BAR Meeting
March 7, 2012

ISSUE: Partial Demolition, Addition and Alterations

LOCATION: 211 Gibbon

**BAR CASE #2012-0016 &
BAR CASE #2012-0017**

Illustration showing walls to be Encapsulated

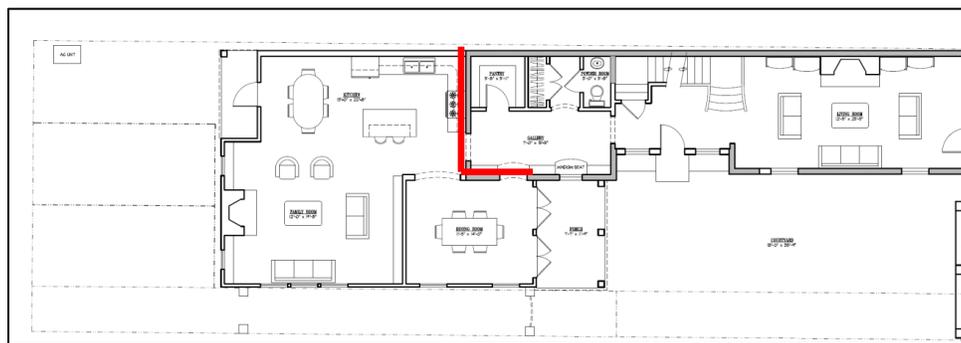
As the attached drawings illustrate, although set back 46 feet from the front property line, the addition will be clearly visible from Gibbon Street. The proposed addition's mass and scale are compatible to the existing Victorian style of the house and are sympathetic to the existing development patterns along the street. However, the proposed alterations and two-story addition will require the encapsulation of the north (rear) wall and 7 feet 4 inches of the c1915 addition's west wall and the reconstruction of the c1900 hyphen's west wall (see illustration below.)

Figure 9: Front Elevation

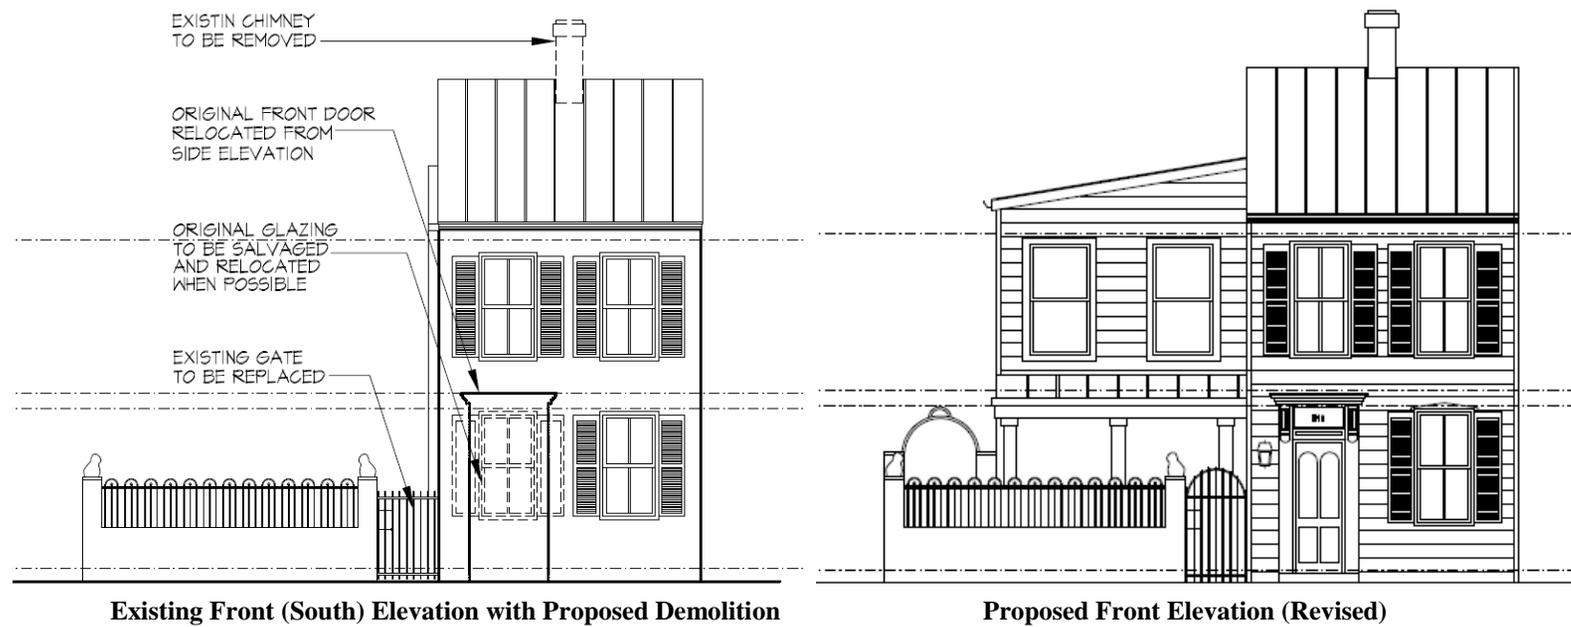
The revised design for the full-width porch from a two-story porch to a one-story porch accomplishes several goals. First, the smaller mass reduces the impact of the addition on the adjacent neighbor. Second, it exposes more wall area of the historic the dwelling to view from the street.

Figure 10: Rear Elevation

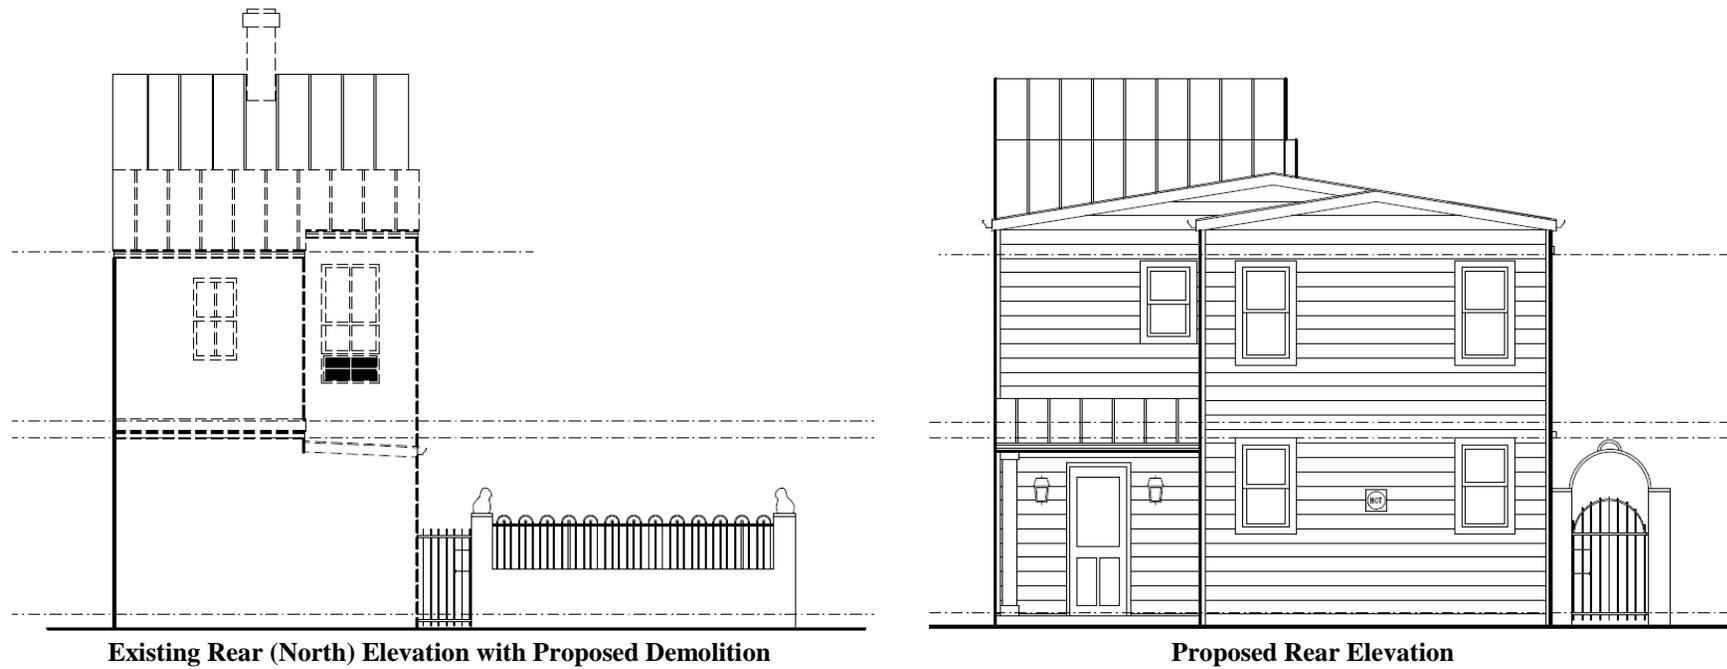
The proposed rear elevation, as viewed from the private alley is awkward, however, this design was utilized order to keep the ridge of the addition understated and maintain the hierarchy in the building masses. This elevation will not visible from a public ROW and will only be visible from a private alley.
